Issue List

02-09-26 QT #0489 CASA GRANDE, AZ

Project Issue Information

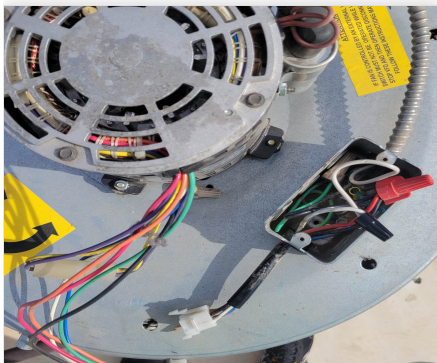
Issue Name : CONDENSER DRAIN IN THE WAY OF DOOR
Description : The door to the mixed air compartment cannot be opened very far, due to the drain being in the way. The economizer control could barely be reached. Recommend adjusting drain to allow full access.
Created By : National TAB **Assigned To :** National TAB - Dan Hertenstein
Status : Open
Priority : Low **Asset Tag :** RT-3
Originated Date : 02/13/2026 - Christine Weale - National TAB

Project Issue Information

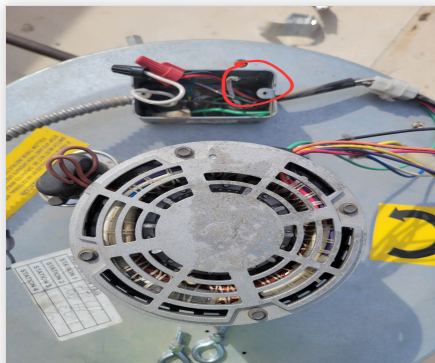
Issue Name : EF1 NO SPEED CONTROLLER
Description : When I arrived, EF1 was improperly wired and not running, I fixed it, but it was running way too high so I disconnected the fan for safety. There should be a safety disconnect switch and a speed control. There isn't, so it's unplugged at the motor connector.
Created By : National TAB **Assigned To :** National TAB - Dan Hertenstein
Status : Open
Priority : Urgent **Asset Tag :** EF1
Originated Date : 02/13/2026 - Christine Weale - National TAB
